PCN – Process Change Notification

Change:	TG35 series
Date:	2016/06/15
Author	Haley Tsai

Model#	Part Number	Changes
TG35 series	TG35 series	1. Change hinge bottom material.
		2. Remove pin.
		3. Change hinge bottom design.
		4. Change assembly method.

Illustration of Change (TG35 series)

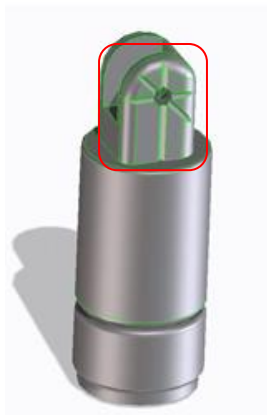
Old material

New material

Original Material	New Material
1. Hinge Top	POM	POM
2. Hinge Bottom	PU	Zinc Alloy
3. SMA ST	Brass	Brass
4. PIN	Brass	None

Old assembly method

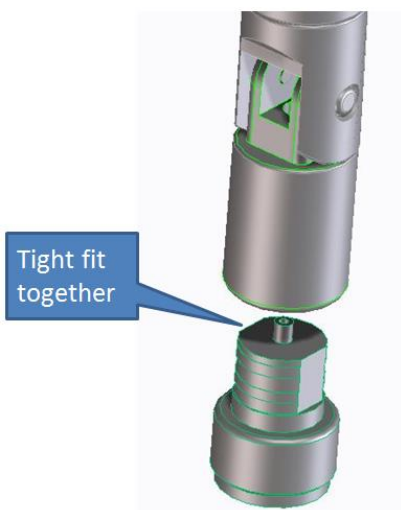
New assembly method
